ADDENDUM TO PROPERTY INSPECTION REPORT PROPERTY INSPECTION AGREEMENT

(SAMPLE REPORT)

ALLIED HOME INSPECTION SERVICES

ADDRESS OF PROPERTY: 9400 DOLIVER # 68

PHOTO NO. 11 BREAKER BOX INSIDE CARPORT CLOSET

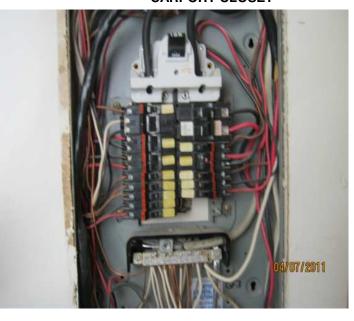
THERE ARE LOOSE - BROKEN ALUMINUM GROUND WIRES AT THE BOTTOM OF THE BREAKER BOX. ALL, OF THE BREAKERS, NEED TO BE LABELED PROPERLY. WIRES, THAT ARE LEAVING THE BREAKER BOX, ARE BUNDLED TOGETHER. THIS IS AN OVER-HEATING ISSUE. THESE WIRES NEED TO BE SPREAD OUT. ALL 15 & 20 AMP CIRCUITS, THAT SERVE LIVING AREAS, ARE MISSING ARC-FAULT BREAKERS. REPAIRS ARE NEEDED. SEE APPENDIX A-2, A-3, A-4, JJ-3, M-2, Y, Y-2, Y-3, AND NEC 210.12 THERE IS NO EVIDENCE OF ANY PIG-TAILING OF THE ALUMINUM BRANCH WIRING.

AS DISCUSSED DURING THE INSPECTION, IT IS STRONGLY RECOMMENDED THAT THE FPE BREAKER BOX BE REPLACED AND UPGRADED TO MEET ALL CURRENT NEC AND CITY OF HOUSTON ELECTRICAL CODES. ESTIMATED COST IS \$2,000 - \$2,500.
